STAFF RECOMMENDATION

NCPC File No. 6367

**FORRESTAL COMPLEX
SECURITY ENHANCEMENTS
1000 Independence Avenue, S.W.
Washington, DC**

Submitted by the Department of Energy

3 PHASE 1-DETAIL SECTION AT 10TH STREET
 A1-02

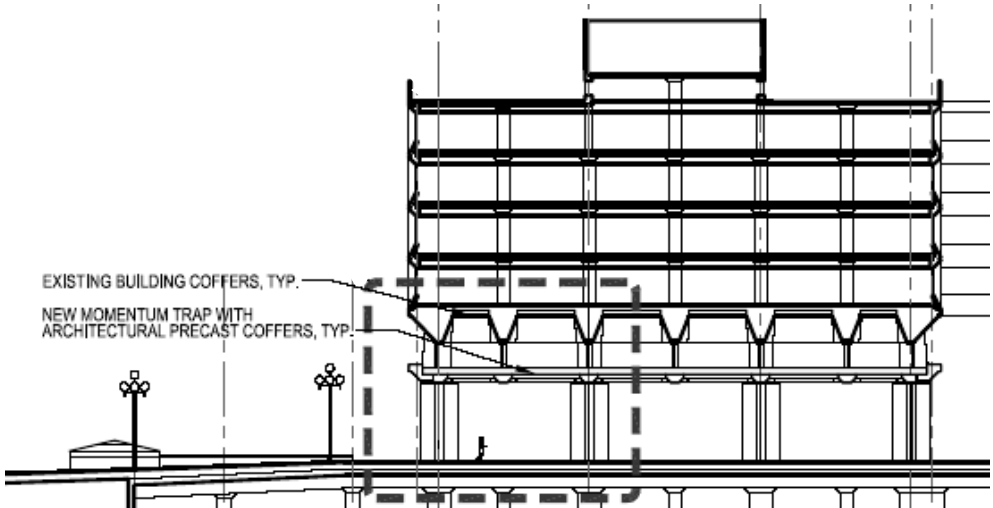
Staff finds this design solution to be a good balance between addressing the applicant's identified security needs and protection of the public realm. The proposal does not limit public access to the space within the building yard, but endeavors to apply a solution that is limited to and compatible with the building architecture. Staff recommends that the increase in column diameter due to this project be minimized as much as possible to retain the design character and proportions of the existing columns.

PHASE 2 – MOMENTUM TRAP BENEATH BUILDING

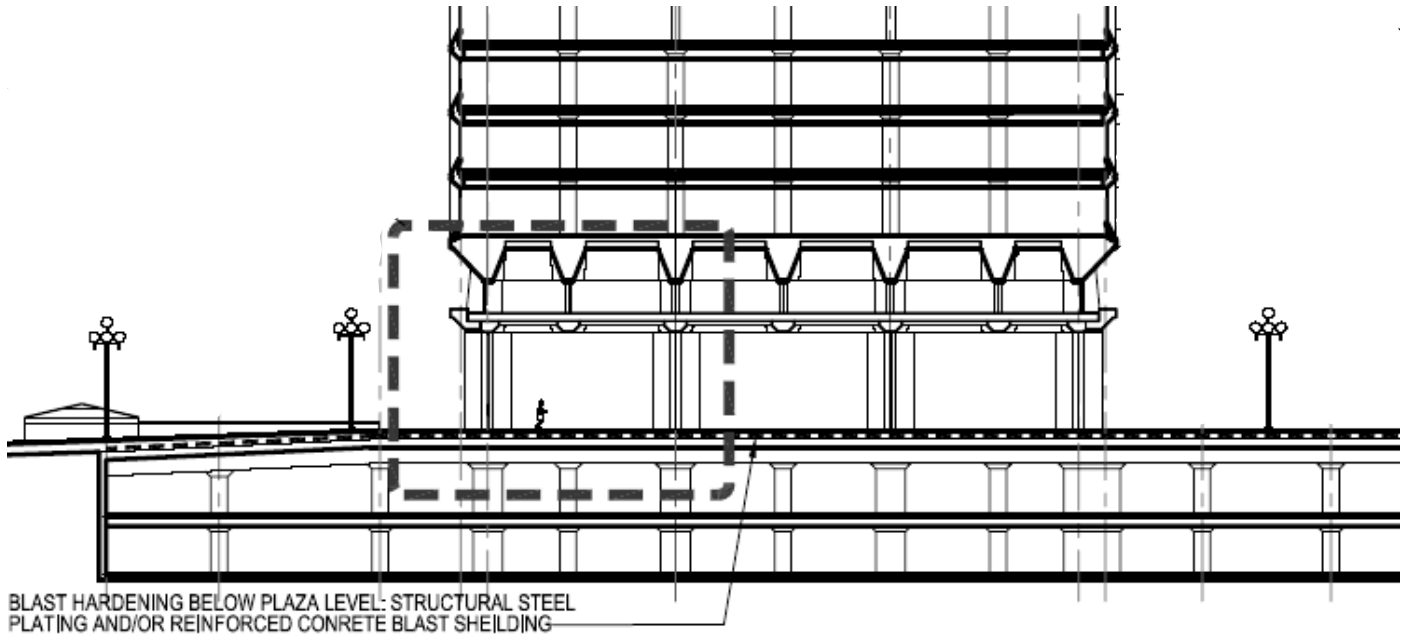
Staff notes that the proposed blast shield reduces the 10th Street vista by approximately one third of its current height. This modification would significantly impact views between the Smithsonian Castle and L'Enfant Plaza. Staff recommends maintaining or reopening the 10th Street vista to the Smithsonian Castle and allowing for a future museum and/or memorial on the 10th Street Overlook site to be seen from the Smithsonian Quad and possibly the Mall beyond.

- Eliminating occupied office space at the first level over the 10th Street Promenade and incorporation of the blast shield within the building mass in this area.
- Removing the portion of the building mass (four column bays) that bridges over the 10th Street Promenade.

PHASE 3 – LOWER LEVEL BLAST HARDENING

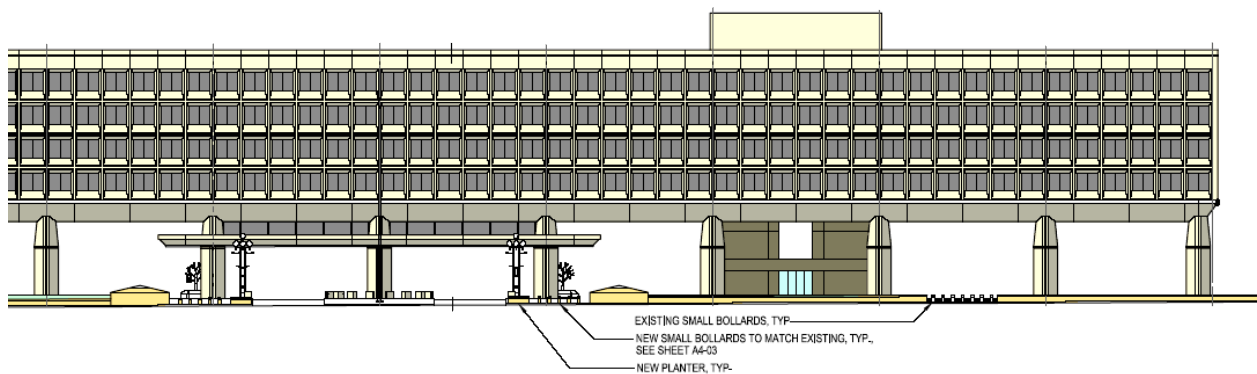
Staff is in support of this phase since 10th Street will be repaired and replaced in-kind and there will be no impacts to the public realm. Project submission materials indicate that Phase 3 work will not result in any changes to the vertical profile of the roadway.

PHASE 4 – PARTIAL SITE PLAN OF CURB AND SIDEWALK WORK AT 10TH STREET BELOW BUILDING

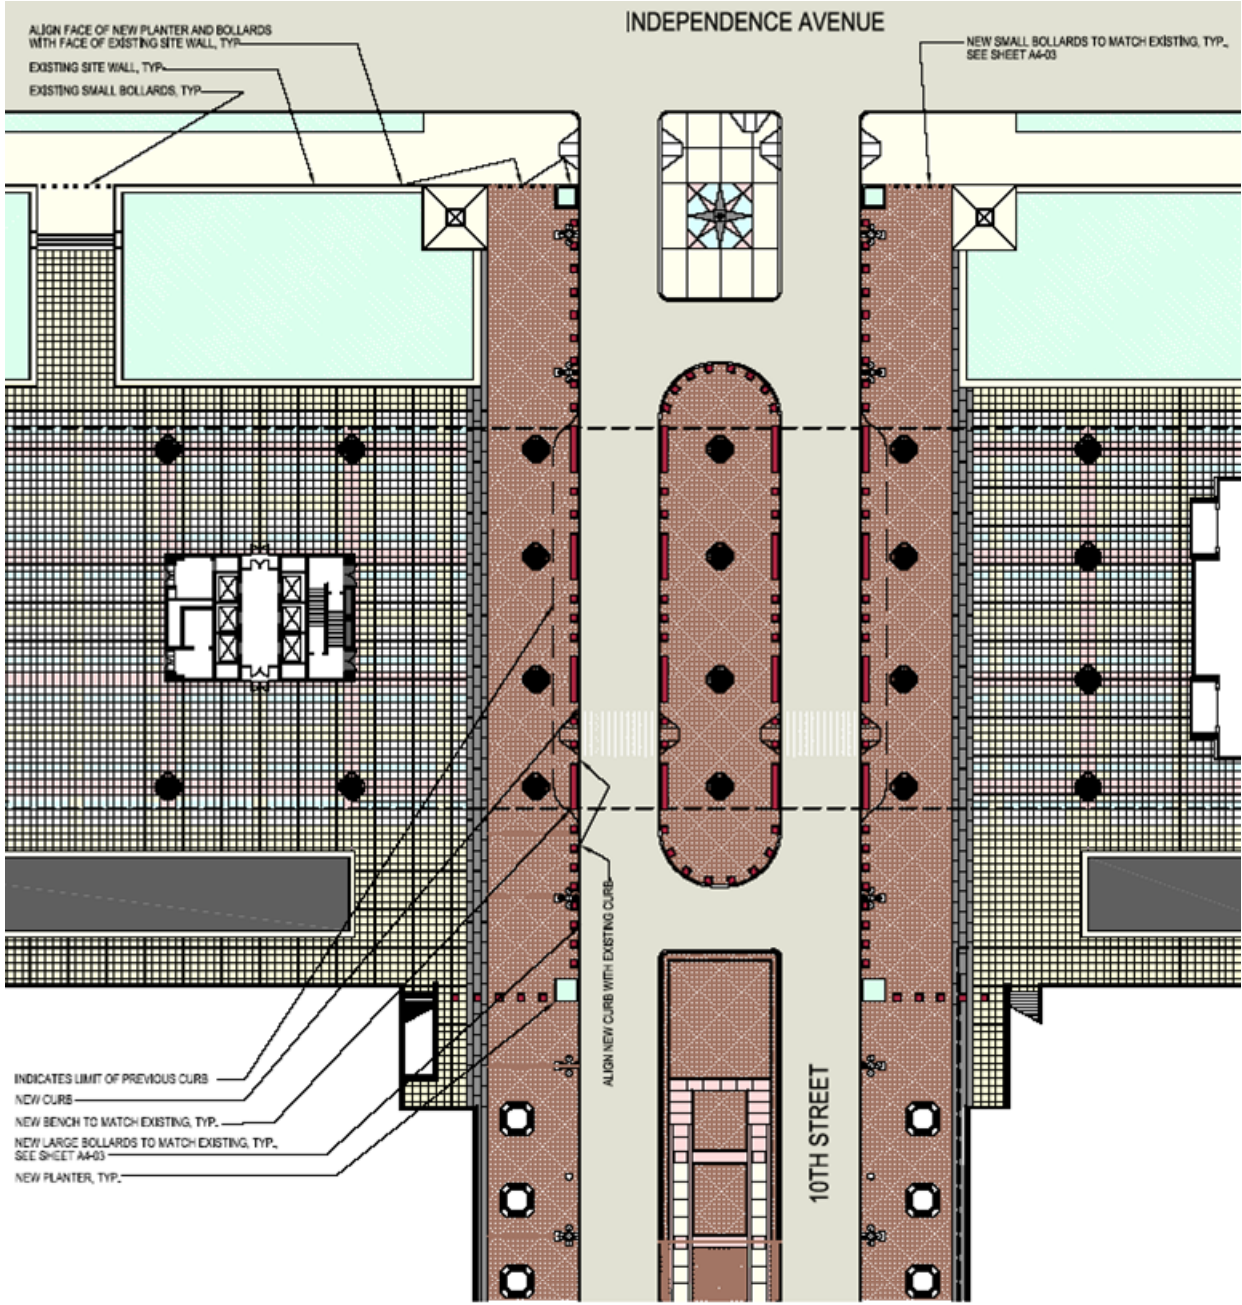
The 10th Street Mall is an important pedestrian and vehicular passage linking the National Mall, L'Enfant Plaza businesses, and, soon, the Children's Museum, 10th Street Overlook, and other future activities of the Southwest Waterfront. Staff notes that security elements that will be placed adjacent to the building columns along 10th Street and the median will impact the public realm and provide minimum additional stand-off distance to the building structure. Additionally, staff finds that the security elements depicted along 10th Street below Building A/B are inappropriate for their setting. The proposal includes many benches in an area that no one is

likely to sit. Since Phases 1, 2 and 3 will provide protective measures to the building structure, staff recommends reducing the line of security elements and placing them in vulnerable areas and/or moving the extent of security elements completely in the building yard per NCPC's final draft of the *National Capital Urban Design and Security Plan Objectives and Policies*. Staff notes that the bench elements located underneath Building A/B along 10th Street and the median, will not appropriately serve pedestrians in those locations and recommends the applicant revise the design with alternative security elements.

Finally, because the removal of the portion of the building mass over 10th Street would impact the need for, and placement of, these elements, staff recommends the programmatic evaluation required for Phase 2 accompany any subsequent submission for Phase 4.

PHASE 5 – DETAIL PLAN AND ELEVATION OF 10TH GUARD BOOTH

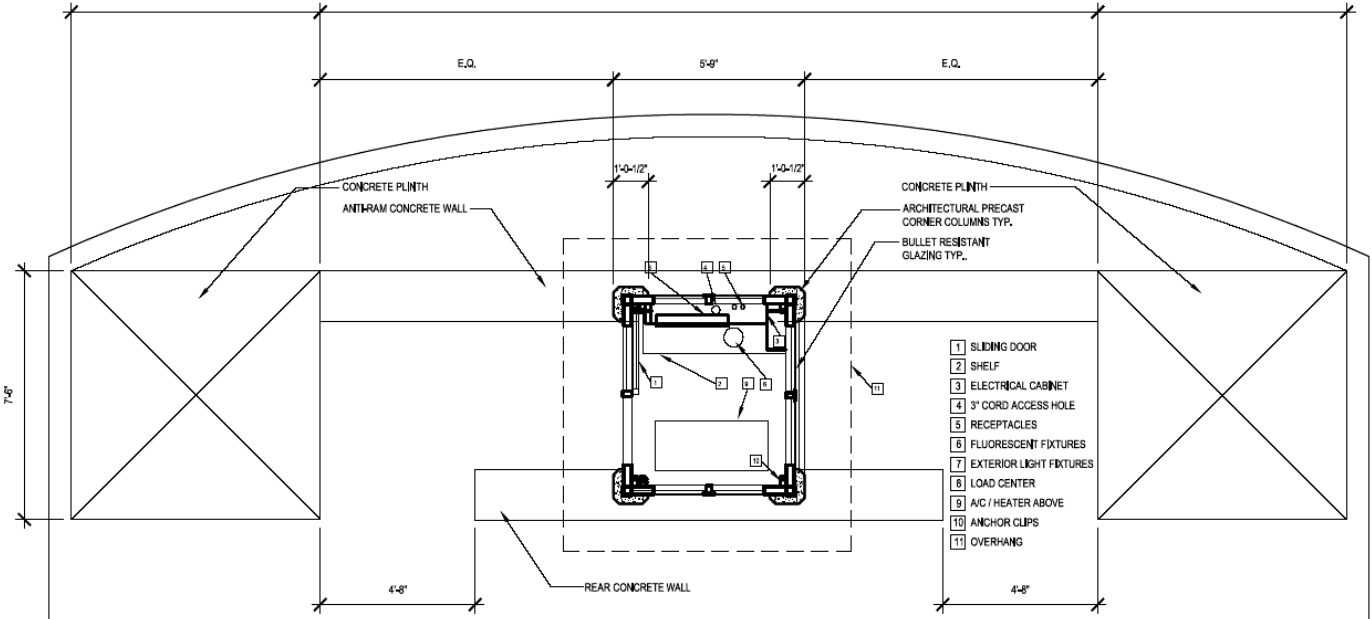
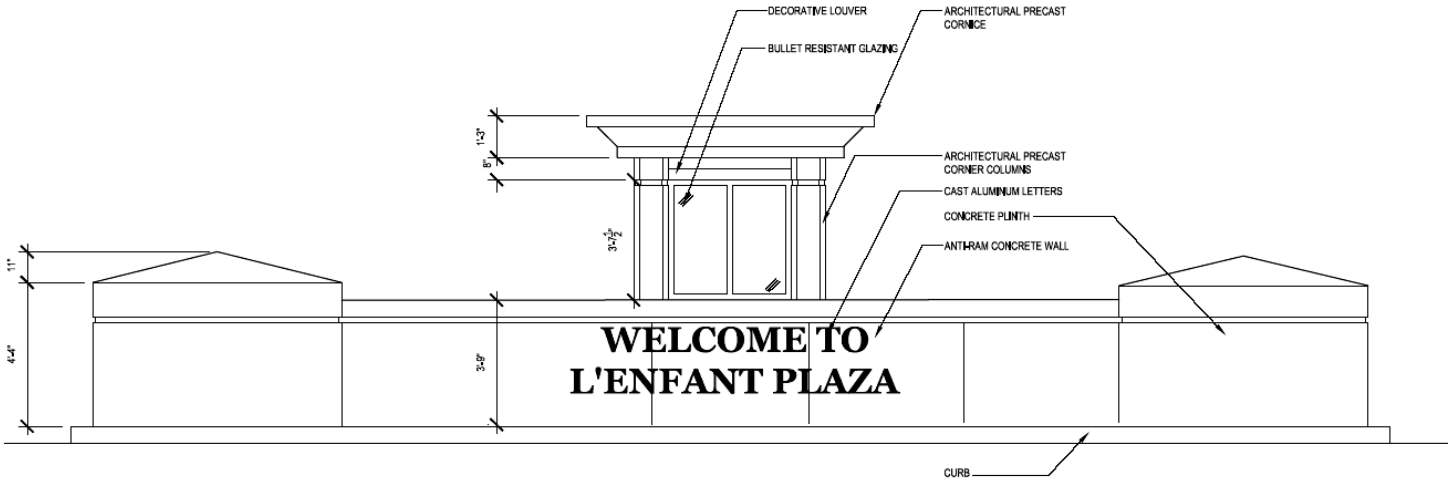
Staff does not support the temporary street closure measures (hydraulic bollards) across 10th Street. Staff is concerned how this closure would impact vehicular traffic on 10th Street and Independence Avenue and ingress/egress of L'Enfant Plaza occupants/tenants and future development on the 10th Street Overlook site.

Staff does not support the placement of guard booths in the median of the L'Enfant Plan rights-of-way or in the 10th Street view-shed.

PHASE 6 – NEW WEST END SECURITY ENTRANCE ENCLOSURE ELEVATION AS SEEN BENEATH BUILDING

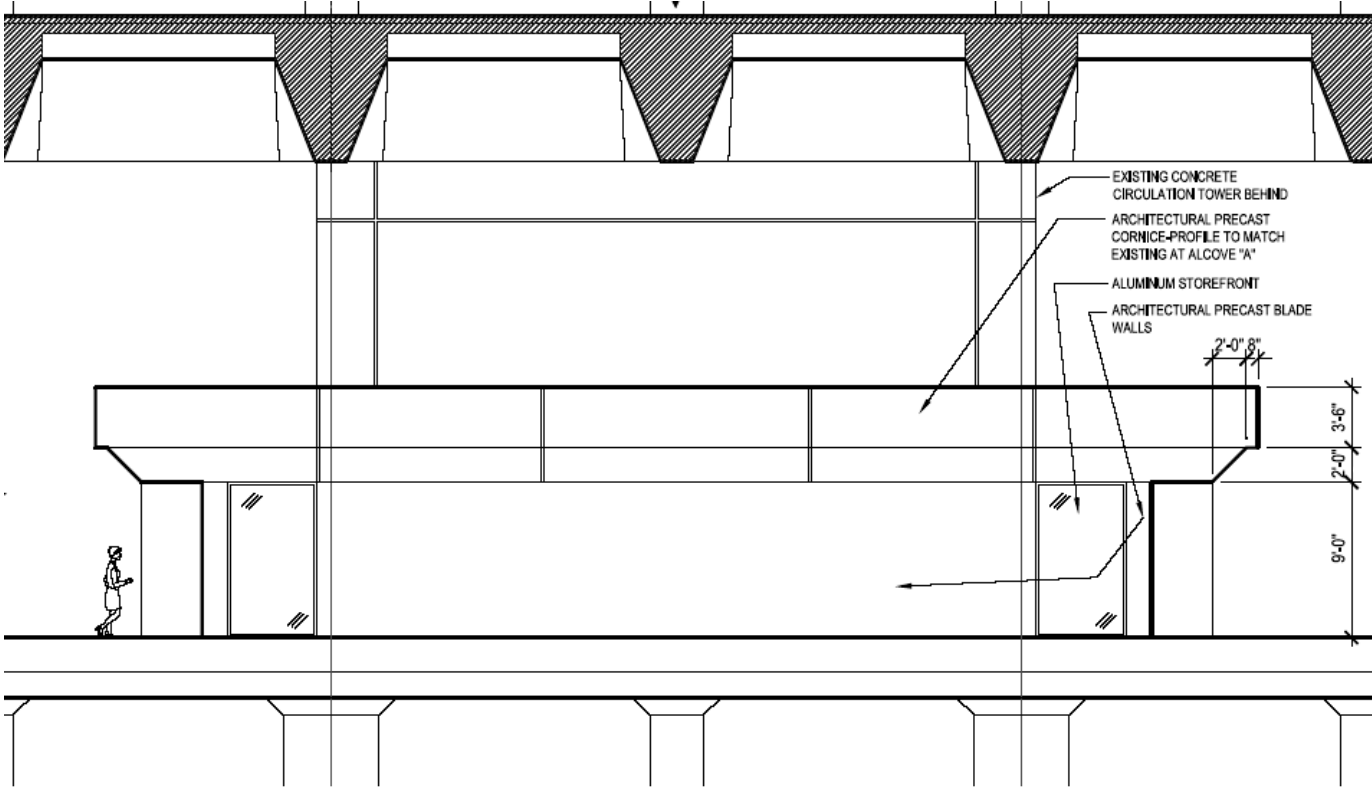
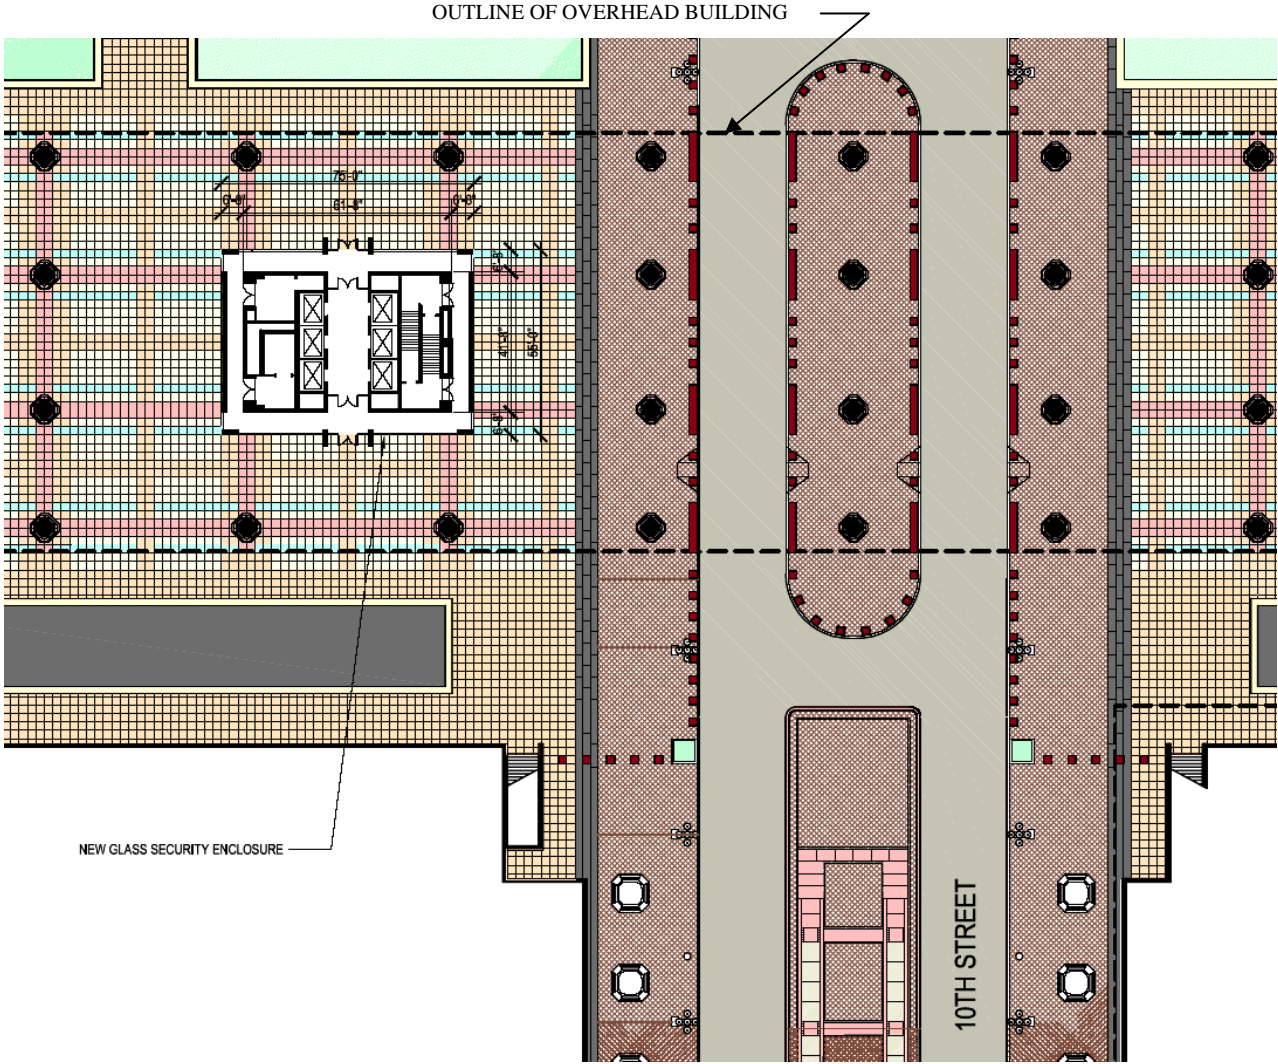
Staff is in support of this phase since the proposed concrete and glass enclosure will be similar in finish and design to the entry lobby core for Building B, located to the east. Alternate Phase 2 solutions may eliminate the necessity of this phase.
